TRANS/WP.29/GRSP/2003/3
21 March 2003

Working Party on Passive Safety (GRSP)

PROPOSAL FOR DRAFT AMENDMENTS TO REGULATION No. 17
(Strength of seats)

Annex 5, the figure, amend to read:

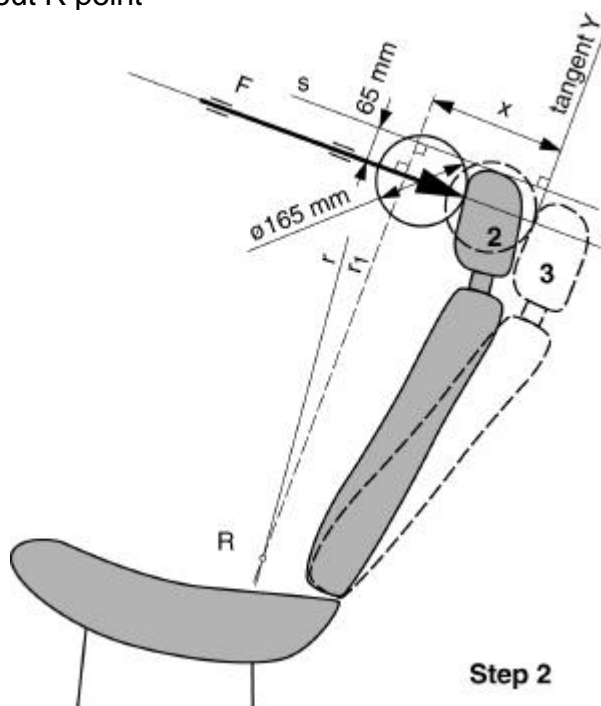
Note: The text reproduced below was prepared by the expert from the Czech Republic in order to better define the figure of annex 5 to the Regulation. It is based on a document distributed without a symbol (informal document No. 17) during the thirty-second session (TRANS/WP.29/GRSP/32, para. 17).

1. Original unloaded position
2. Displaced position by a moment of 37.3 daNm of manikins's back in relation to R point
3. Position after displacement by an initial force F producing a moment of 37.3 daNm about R point

VERSION B: x compatible with paragraph 6.4.3.5.
